# Access Compliance Report

## Public Rights-of-Way

Intersection ID: 15394	Main Street: HERMAN_AV	Cross Street: S_TRYON_ST	Location: NE
ADA ID: EDBC1051CA8E	Ramp Type: PerpDiag	Initial Pass/Fail: Fail	Overall Compliance: No
Severity Score: 25			
Codes/Mitigation Info/Possible Solution		Field Measurements/Component Compliance

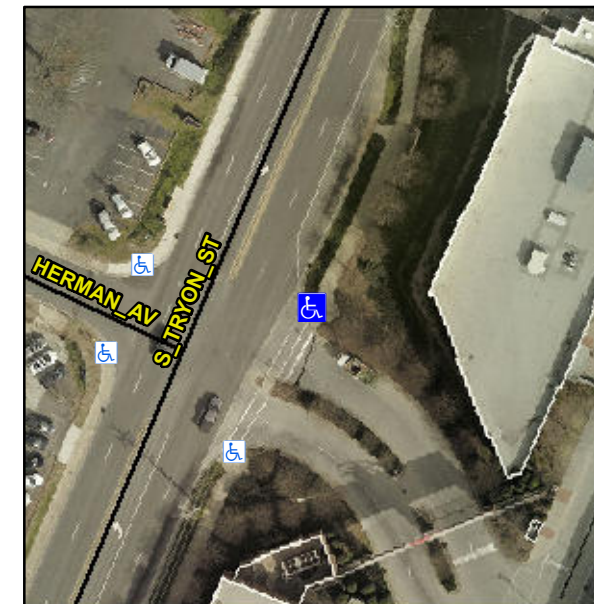
**R304.5.3**

Compliance	Description	Data	Compliance	Description	Data
N/A	Ramp Length (in)	96.0	Yes	Ramp Slope (%)	7.8
Yes	Ramp Width (in)	50.0	No	Ramp XSlope (%)	8.7
N/A	Flare Type LT	N/A	N/A	Flare Type RT	N/A
N/A	Flare Slope LT (%)	N/A	N/A	Flare Slope RT (%)	N/A
N/A	Flare Traversable LT?	N/A	N/A	Flare Traversable RT?	N/A
N/A	Landing Length (in)	N/A	N/A	DWS Provided?	N/A
N/A	Landing Width (in)	N/A	N/A	DWS Contrast?	N/A
N/A	Landing Slope (%)	N/A	N/A	DWS Length (in)	N/A
N/A	Landing X Slope (%)	N/A	N/A	DWS Full Width?	N/A
N/A	Landing Curb? (Y/N)	N/A	N/A	DWS Offset (in)	N/A
N/A	Shared Landing?	N/A			
N/A	Gutter Ponding?	N/A	N/A	Gutter Slope (%)	N/A
N/A	Gutter Lip Ht (in)	N/A	N/A	Gutter X Slope (%)	N/A
N/A	Painted X Walk1?	No	N/A	Painted X Walk2?	Yes
	X Walk 1 Direction	To NW		X Walk 2 Direction	To SW
N/A	X Walk 1 Width (in)	N/A	N/A	X Walk 2 Width (in)	60.0
	X Walk 1 Slope (%)	9.3		X Walk 2 Slope (%)	4.6
	X Walk 1 X Slope (%)	2.1		X Walk 2 X Slope (%)	7.9

**Remove & Replace Curb Ramp With Two New Directional Ramps or Equivalent.**
